ENERGY NORTHWEST

April 28, 2003
GO2-03-069

Subject: **COLUMBIA GENERATING STATION, DOCKET NO. 50-397
REQUEST FOR ADDITIONAL INFORMATION REGARDING A
REQUEST FOR AMENDMENT TO TECHNICAL SPECIFICATION
2.1.1.2, MCPR SAFETY LIMIT AND SR 3.3.1.3.2, OSCILLATION
POWER RANGE MONITOR-LPRM CALIBRATION FREQUENCY**

**REQUEST FOR ADDITIONAL INFORMATION REGARDING REQUEST FOR
AMENDMENT TO TECHNICAL SPECIFICATION 2.1.1.2 AND SR 3.3.1.3.2**

Figure 1

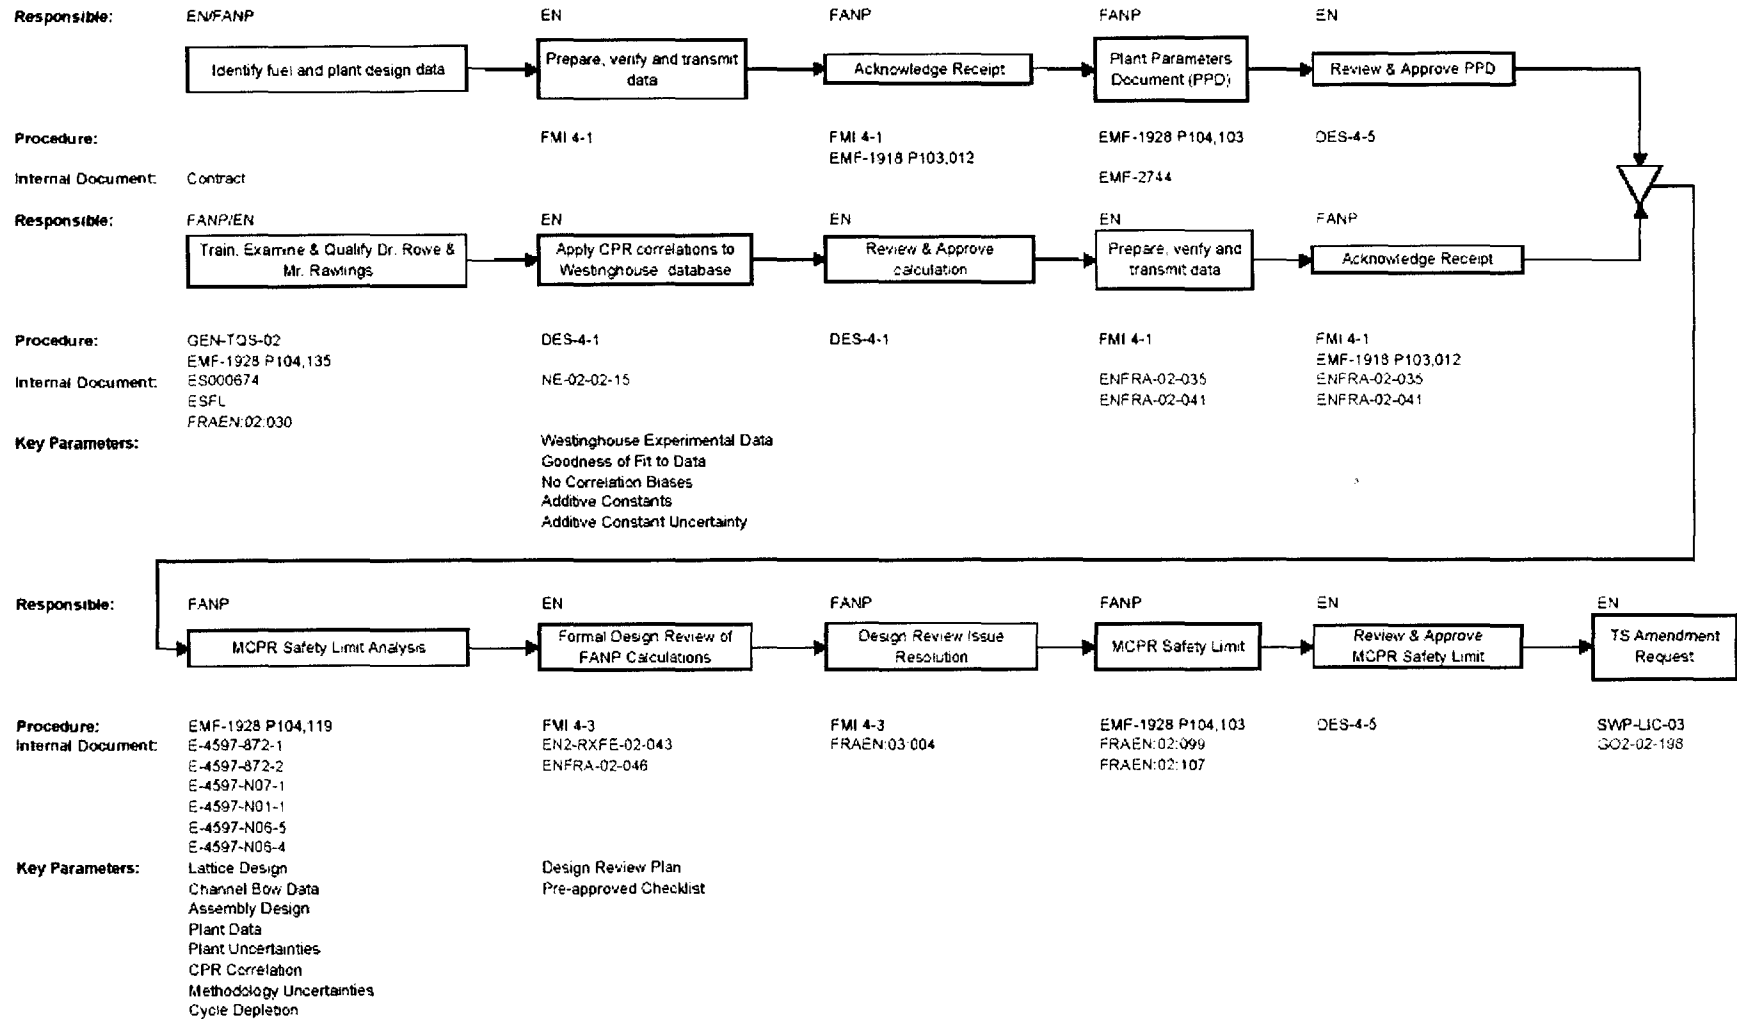
“Cycle 17 will be the first cycle of operation with a mixed core of ABB/CE/Westinghouse SVEA-96 fuel and Framatome ANP ATRIUM-10 reload fuel. Provide a flow chart for the calculation interface and identify those key parameters in the calculation. Also, describe any applicable safeguard procedures used to verify that the mixed core analysis for the SLMCPR are accurate without any possible input errors for the calculation, and identify any routine check-out processes to verify that the result of the calculation for SLMCPR is conservative.”

With regards to the last sentence, provide a description of the processes used to ensure the information that is transmitted between the interfaces is accurate, correctly applied and the results are consistent and reasonable. Reference any procedures that implement the processes described.

A flow chart, Figure 1, shows the Energy Northwest and Framatome ANP processes and interfaces that were utilized in determining the SLMCPR for Cycle 17. Table 1 provides a summary of the procedures and documents identified on the flow chart. Each summary describes the activity involved in the respective step of the overall design control process. Those steps that involve review of data for accuracy and completeness are shown on the figure and described in the table. The design control process complies with the requirements of 10 CFR 50 Appendix B.

The boxes in the flow chart identify the major activities associated with the overall design control process. The organization(s) responsible for each major activity is shown above each box. Implementing procedure(s) and the internal document(s) or output result, for each major activity are listed below each box.

Key parameters associated with the activity were obtained for the areas identified on the flow chart. More specific information regarding the parameters used in the SPCB CPR correlation is provided in ENFRA-02-035 and ENFRA-02-041 (Enclosure 4, References A.4 and A.5 and Table A.1 of Reference 1).

Based on following the process described above, we are confident that the data transmitted between Energy Northwest and Framatome ANP are accurate and the results are consistent and reasonable.
